PRELIMINARY/FINAL DRAINAGE REPORT

SPACE VILLAGE FILING NO. 3

PCD Project No. SP-17-009 & SF-18-016

Markup Summary

Final Plat of:
SPACE VILLAGE FILING NO. 3
A SUBDIVISION IN THE NORTHWEST QUARTER OF SECTION 17, TOWNSHIP 14 SOUTH, RANGE 65 WEST OF THE SIXTH PRINCIPAL MERIDIAN,
(Unincorporated area) COUNTY OF EL PASO, STATE OF COLORADO

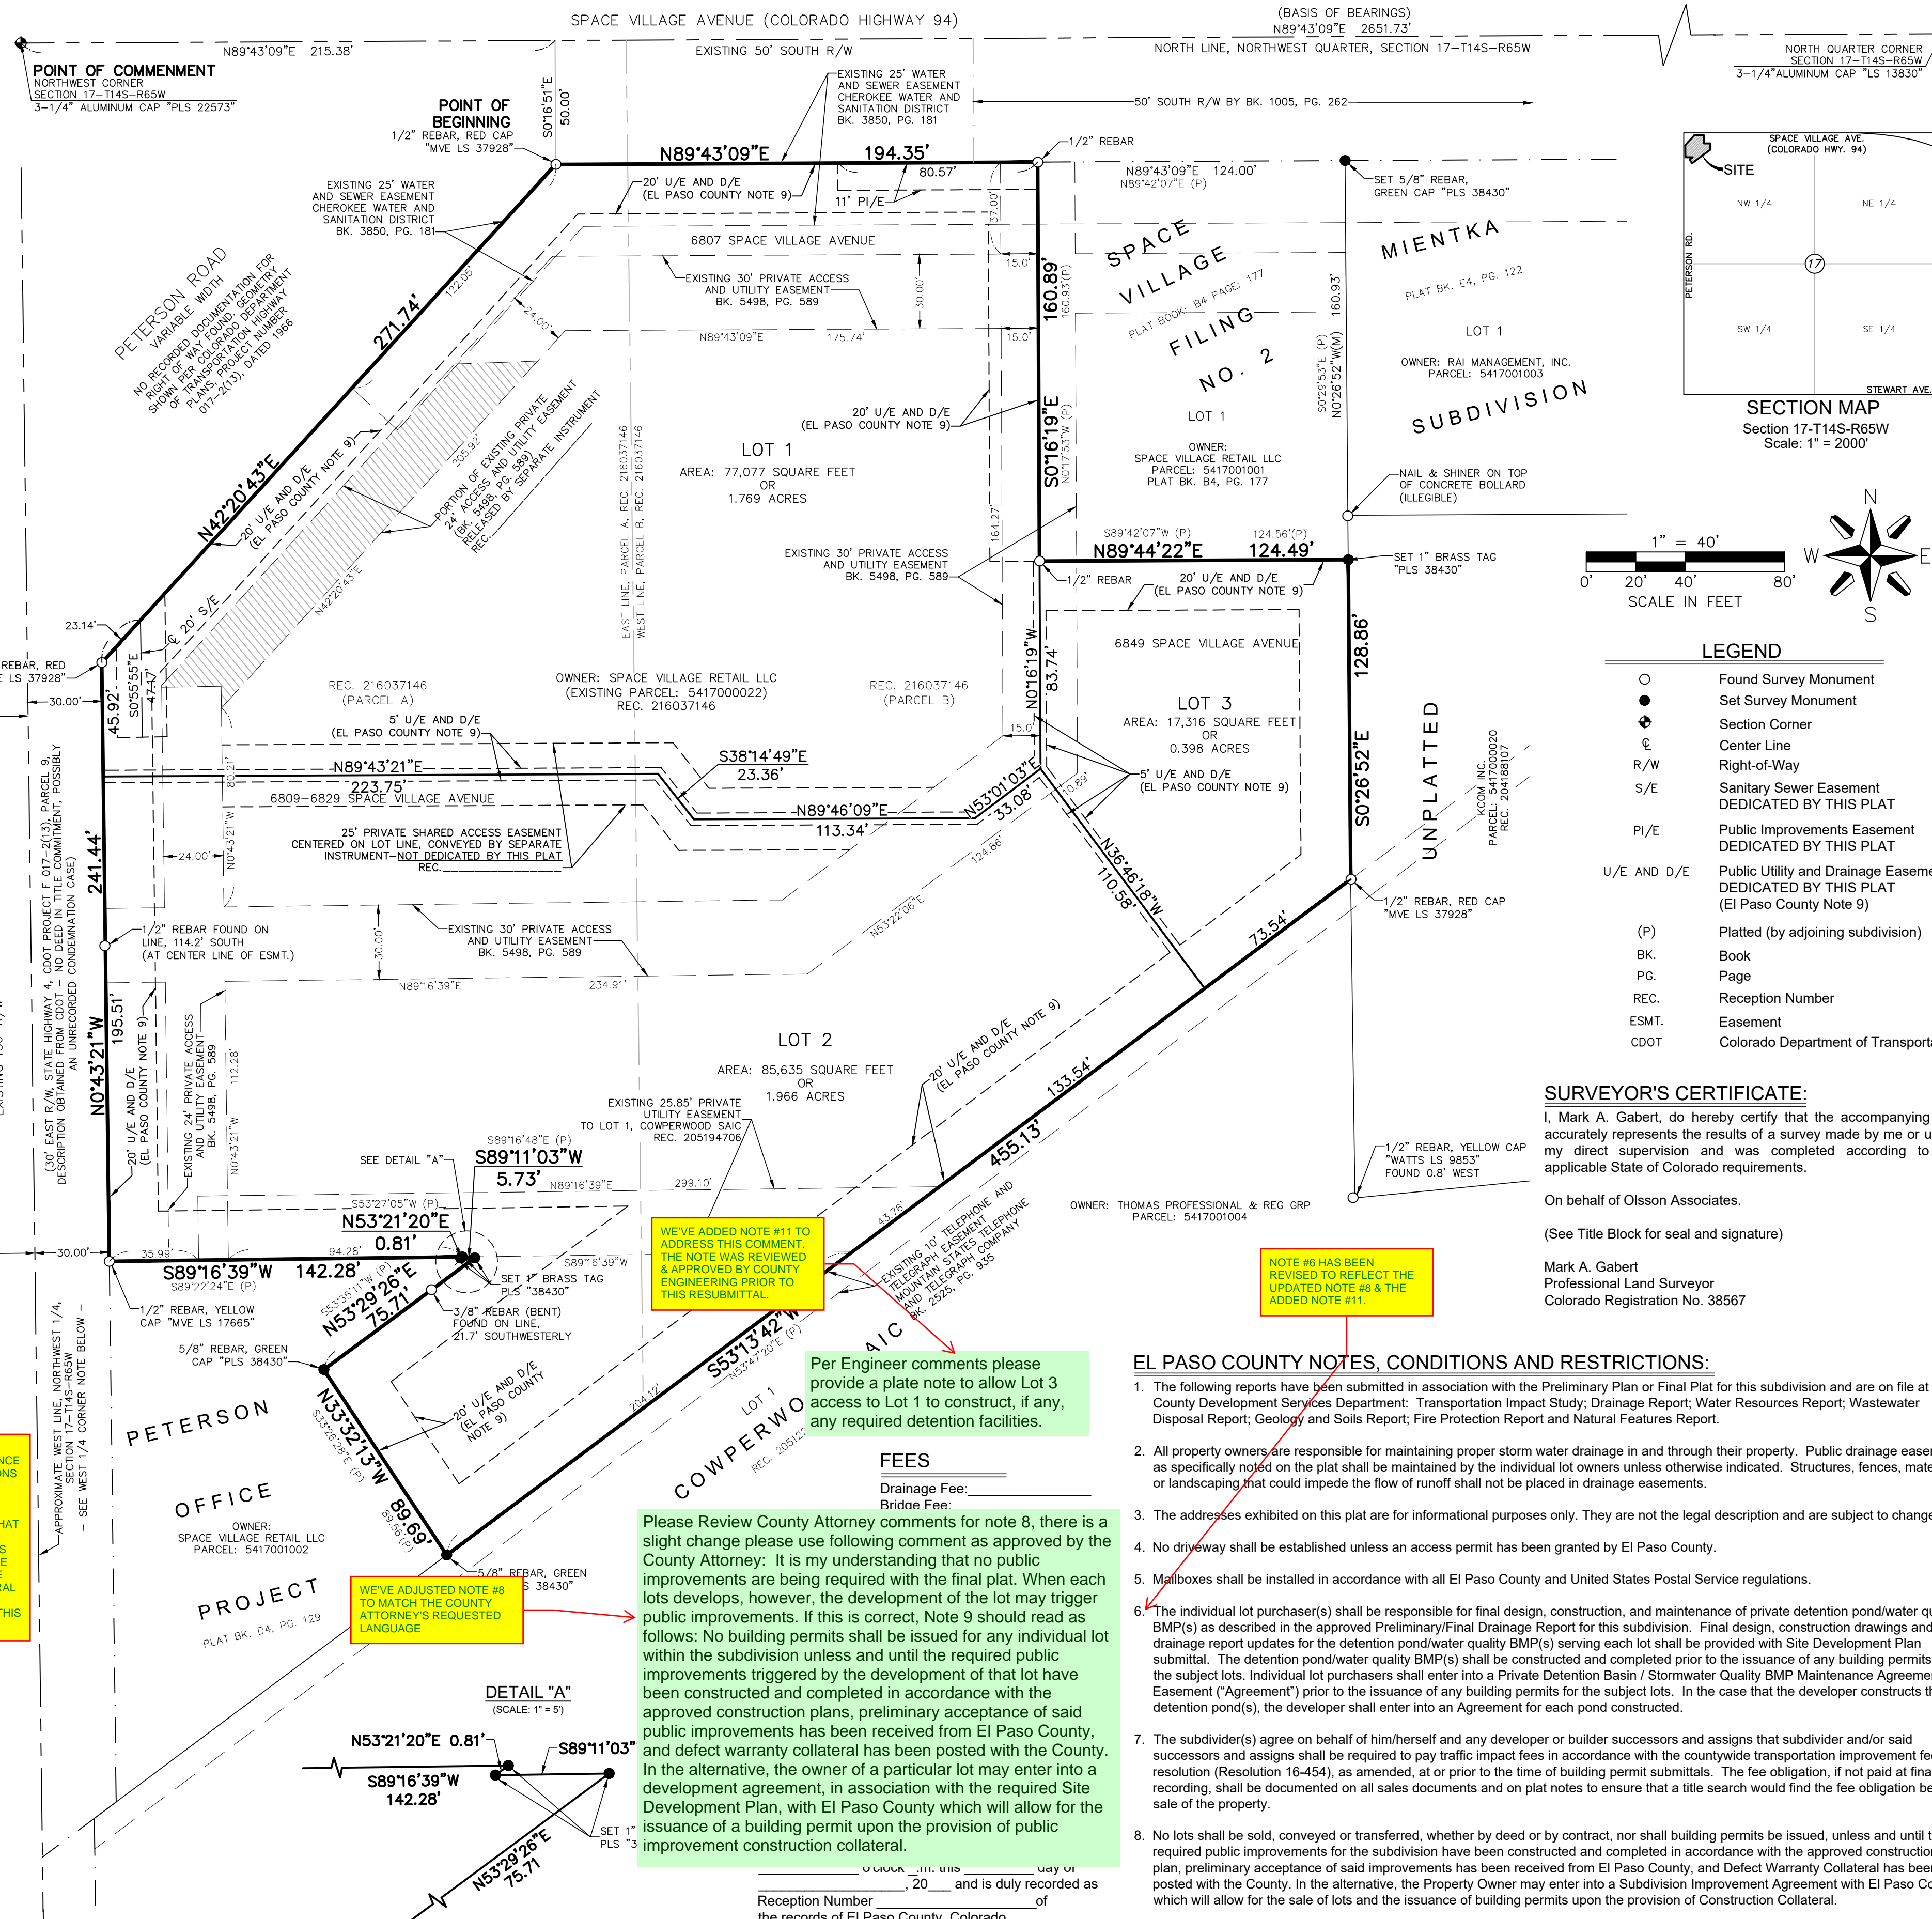
Please combine all notes as general notes, when referring to water district this is our standard note. The water and sanitation is provided by Cherokee Metropolitan District.

Please Review County Attorney comments for note 8, there is a slight change please use following comment as approved by the County Attorney: It is my understanding that no public improvements are being required with the final plat. When each lots develops, however, the development of the lot may trigger public improvements. If this is correct, Note 9 should read as follows: No building permits shall be issued for any individual lot within the subdivision unless and until the required public improvements triggered by the development of that lot have been constructed and completed in accordance with the approved construction plans, preliminary acceptance of said public improvements has been received from El Paso County, and defect warranty collateral has been posted with the County. In the alternative, the owner of a particular lot may enter into a development agreement, in association with the required Site Development Plan, with El Paso County which will allow for the issuance of a building permit upon the provision of public improvement construction collateral.

Per Engineer comments please provide a plate note to allow Lot 3 access to Lot 1 to construct, if any, any required detention facilities.

"PROPERTY NOTES" HAS BEEN CHANGED TO "EXISTING ENCUMBRANCE NOTES" SINCE THESE ARE EXCEPTIONS TAKEN DIRECTLY FROM THE TITLE COMMITMENT. WE DID NOT CHANGE THE WORKING IN THE EXCEPTIONS FROM THE TITLE COMMITMENT SO THAT THEY WOULD MATCH VERBATIM. WE NEED TO MAINTAIN SEPARATE NOTES HERE, SO HOPEFULLY CHANGING THE NOTE TITLES IS ACCEPTABLE TO THE COUNTY. WEVE ALSO ADDED GENERAL NOTE #5 WHICH INDICATES THE SURVEYOR FOR WATER/SEWER ON THIS PROJECT.

WEVE ADDED NOTE #11 TO ADDRESS THIS COMMENT. THE NOTE WAS REVIEWED & APPROVED BY COUNTY ENGINEERING PRIOR TO THIS RESUBMITTAL.

WEVE ADJUSTED NOTE #8 TO MATCH THE COUNTY ATTORNEY'S REQUESTED LANGUAGE

SPACE VILLAGE FILING No. 3 PRELIMINARY PLAN

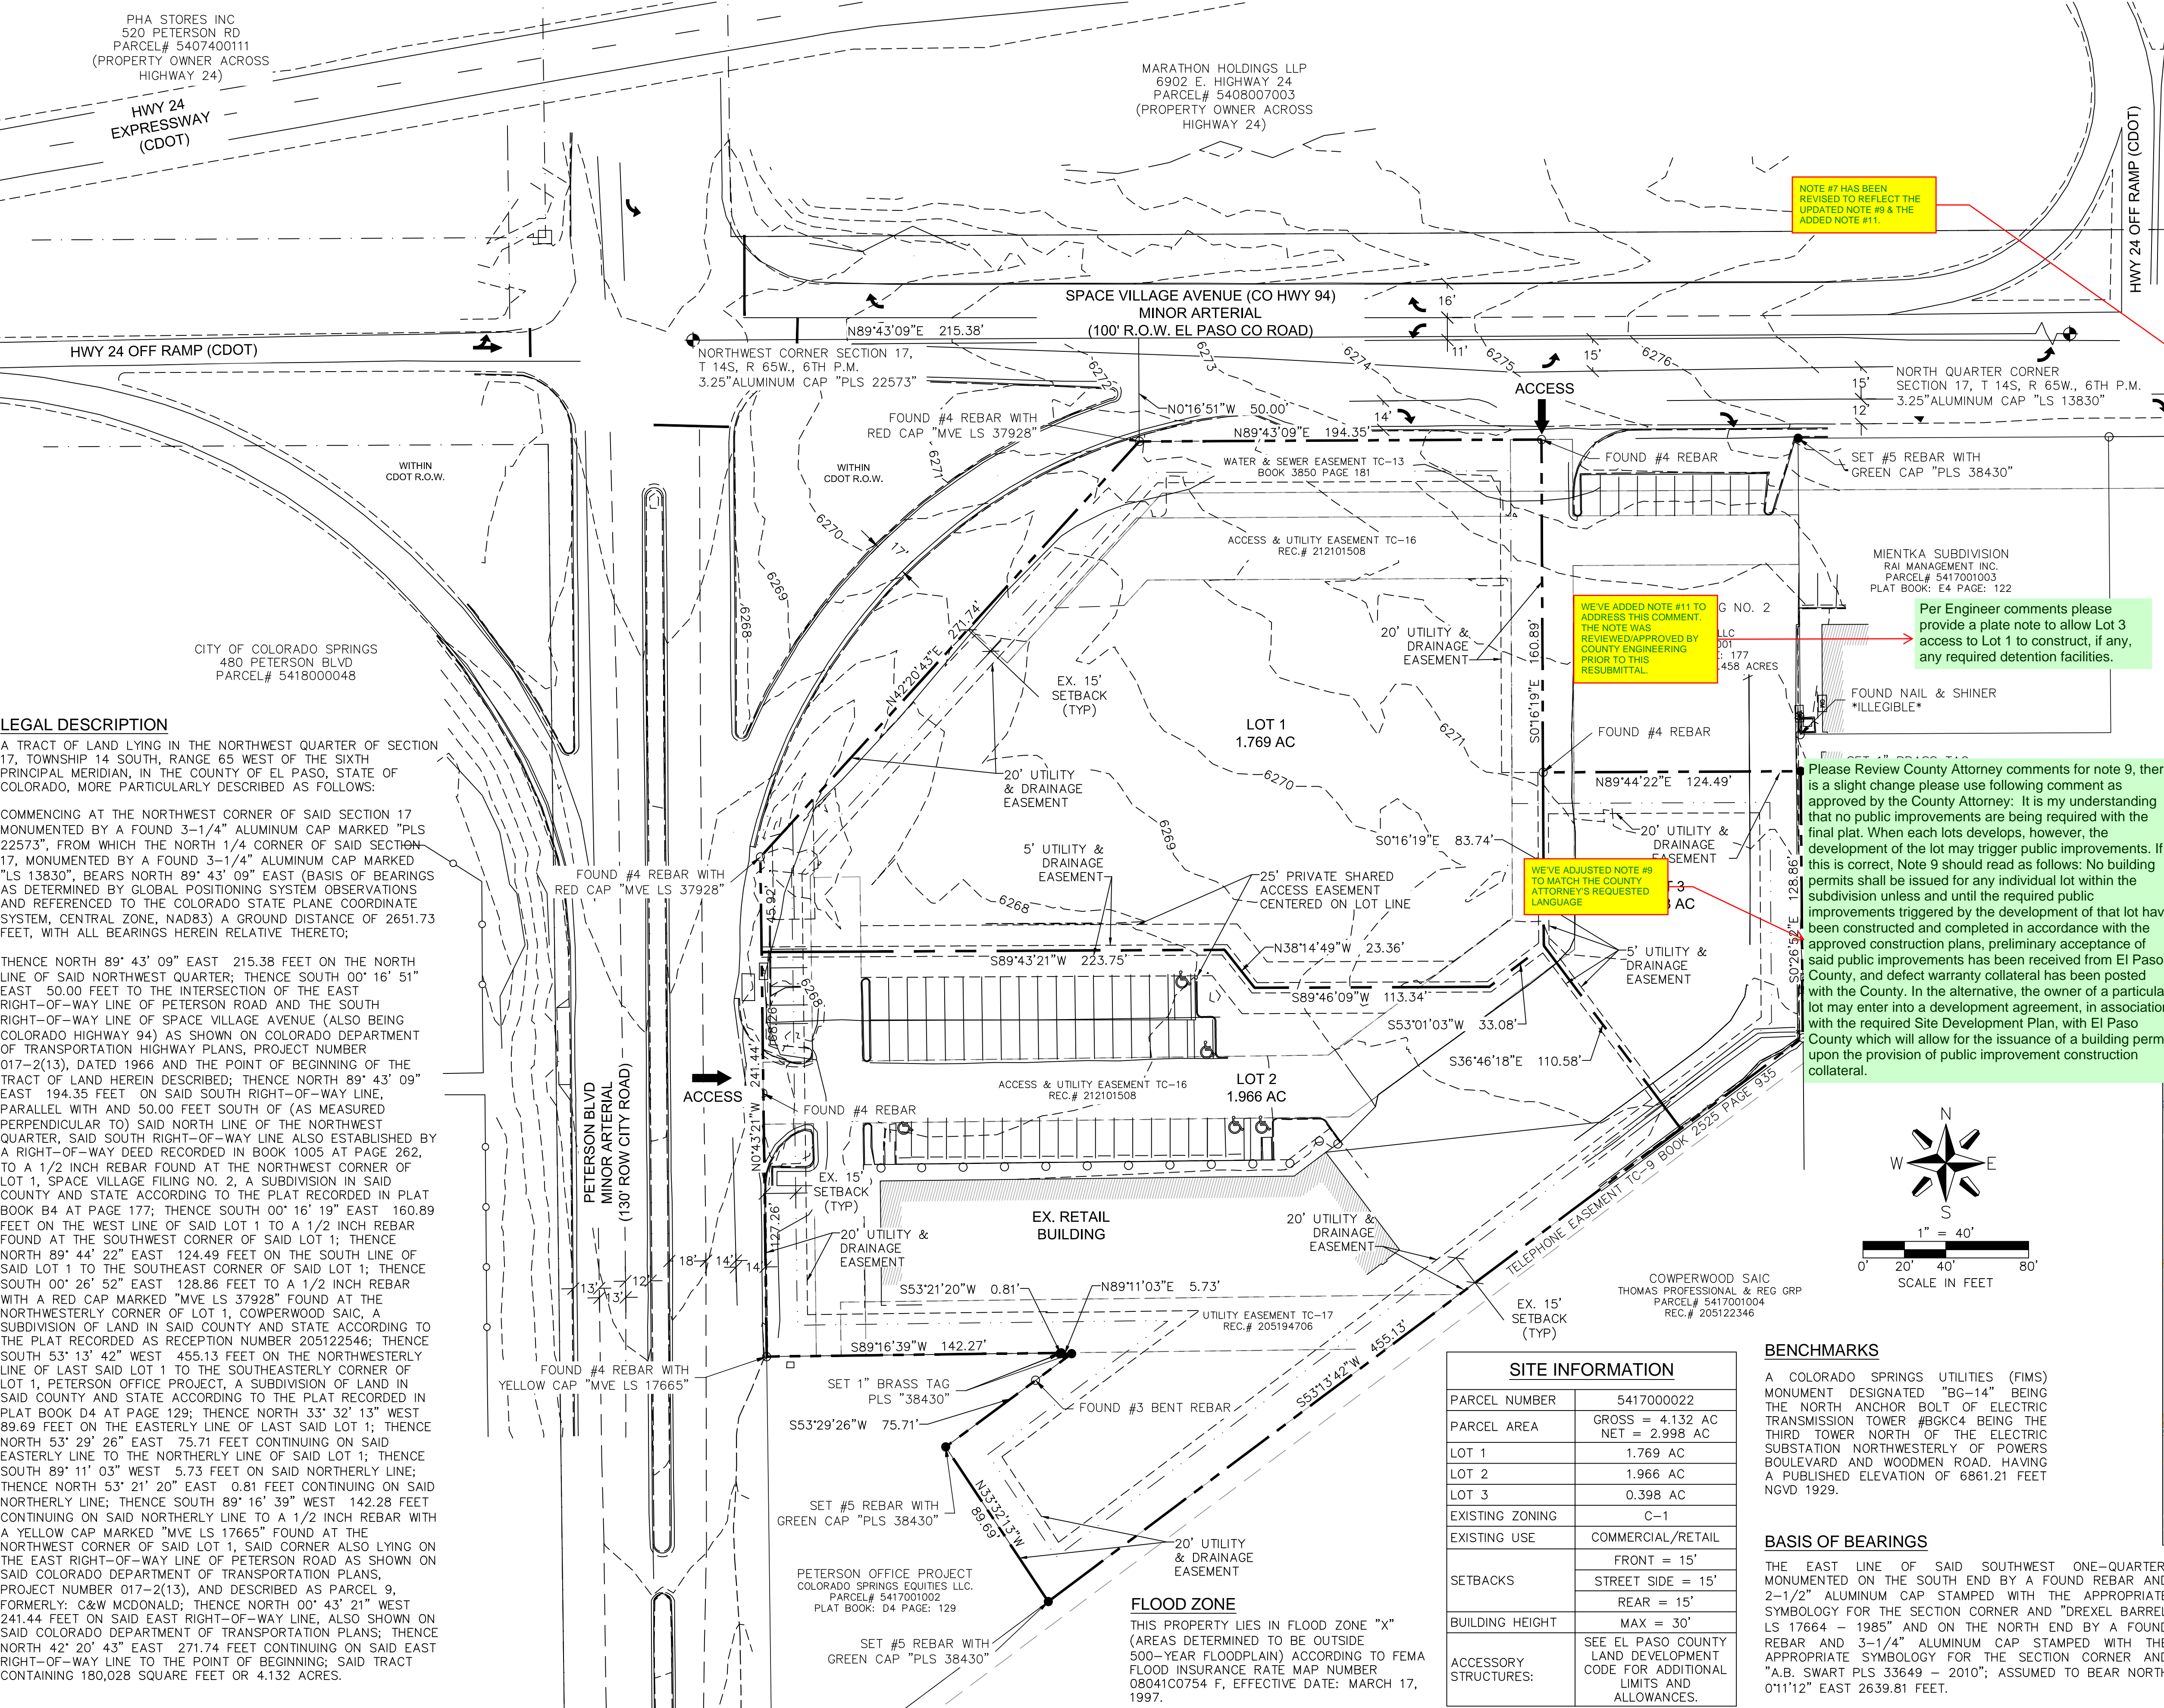
Per Engineer comments please provide a plate note to allow Lot 3 access to Lot 1 to construct, if any, any required detention facilities

Please Review County Attorney comments for note 9, there is a slight change please use following comment as approved by the County Attorney: It is my understanding that no public improvements are being required with the final plat. When each lots develops, however, the development of the lot may trigger public improvements. If this is correct, Note 9 should read as follows: No building permits shall be issued for any individual lot within the subdivision unless and until the required public improvements triggered by the development of that lot have been constructed and completed in accordance with the approved construction plans, preliminary acceptance of said public improvements has been received from El Paso County, and defect warranty collateral has been posted with the County. In the alternative, the owner of a particular lot may enter into a development agreement, in association with the required Site Development Plan, with El Paso County which will allow for the issuance of a building permit upon the provision of public improvement construction collateral.
